Service Bulletin

Sterndrive No. 2004-07

Correction to Installation Manuals

HP377 Sterndrive, HP500 EFI, HP525 EFI, HP575 SC and HP600 SCi installation manuals

INCORRECT ILLUSTRATION

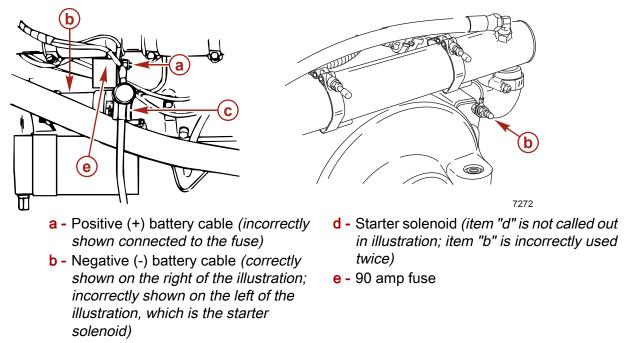
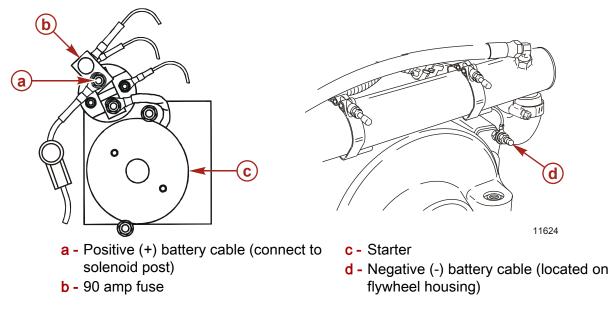
The following illustration used in the installation manuals for the above listed products, is incorrect. The positive battery cable connection to the engine's starter is incorrectly shown connected to the 90 amp starter fuse. Callout item "b", which is the negative (-) battery cable connection, is pointing to two places. On the right, it is pointing to the proper location. On the left, it is pointing to the starter solenoid. This is incorrect. Callout item "d" is not shown in the illustration.

The following new illustration has been created to show the correct connection of the battery cables to the engine. This new graphic will be in future revisions of installation manuals for the HP525 EFI and the HP600 SCi. Since the HP377 Sterndrive, HP500 EFI and HP575 SC are no longer in production, their installation manuals will not be updated.
